APPLICATION NO.	FILING DATE	FIRST NAMED INVENTOR	ATTORNEY DOCKET NO.	CONFIRMATION NO.
10/822,706	04/13/2004	Tomotoshi Senoh	086142-0629	2928
22428	7590	12/20/2005	EXAMINER	
FOLEY AND LARDNER LLP SUITE 500 3000 K STREET NW WASHINGTON, DC 20007				KAYES, SEAN PHILLIP
			ART UNIT	PAPER NUMBER
			2841

<b>Office Action Summary</b>	<b>Application No.</b>	<b>Applicant(s)</b>	
	10/822,706	SENOH ET AL.	
	Examiner Sean Kayes	Art Unit 2841

## DETAILED ACTION

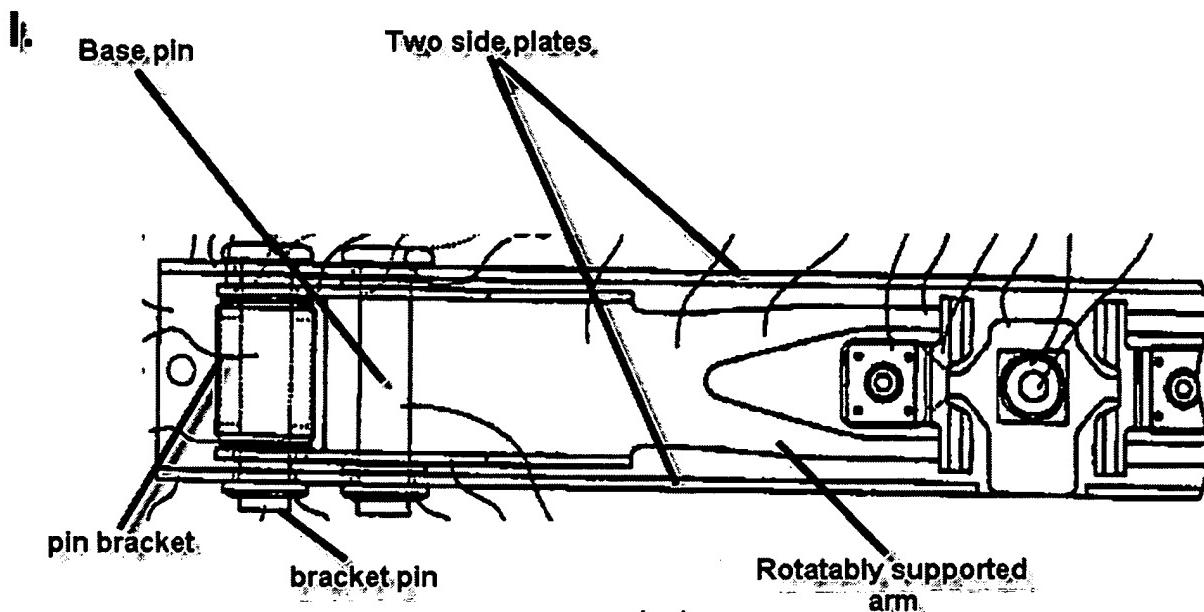
11. With respect to claim 7, Aoki discloses a device for measuring seat weight including the weight of an occupant sitting on the seat, the device comprising: a base having two side plates (see picture I. provided below); an arm rotatably supported by and interdisposed between the side plates of the base via a base pin (see picture I. provided below, and item 31 figure 4); a pin bracket in communication with the arm via a bracket pin and further in communication with the seat (see picture below, and items 25 and 27 figure 4); a load sensor in communication with the arm; and wherein the pin bracket is located between the base pin and the load sensor. Aoki does not explicitly

disclose wherein the device is configured so that the weight of the seat is applied between the at least one support point and the sensor point.

At the time of the invention it would have been obvious to one skilled in the art to switch the position at which the weight of the seat acts, from one pin to the other. Such a change would be a mere rearrangement of parts.

The suggestion or motivation for doing so would be to change to apply a different force at the sensor position. This would allow the invention to adjust the force applied at the sensor position to be within an ideal range.

14. With respect to claim 10, Aoki discloses the device of claim 7 (see 103 rejection above), wherein the pin bracket of the present invention is rotatably supported by the base pin ((figure 4 and column 2 lines 25-30 and see picture I. provided above.)

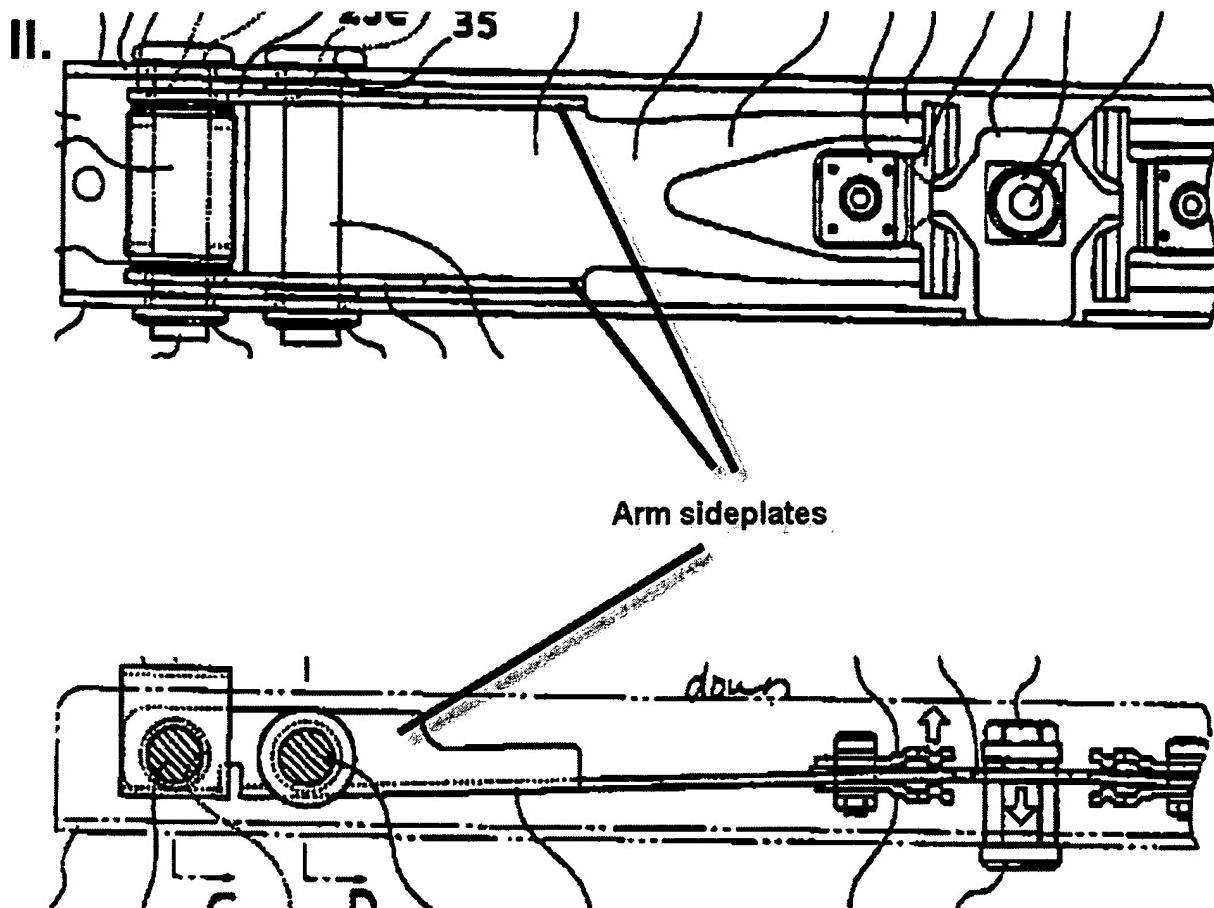
16. With respect to claim 12, Aoki discloses the device of claim 7 (see 103 rejection above), wherein the arm comprises two arm sideplates (see picture II. provided below.)

17. With respect to claim 13, Aoki discloses the device of claim 12 (see 103 rejection above.) Aoki does not explicitly disclose a spring leaf interdisposed between the two arm side plates.

At the time of the invention it would have been obvious to one skilled in the art to replace the springs in Aoki's invention with leaf springs.

The suggestion motivation for doing so would be to increase longevity of the springs. Leaf springs are less subject to deformation due to continuous load as are traditional springs.
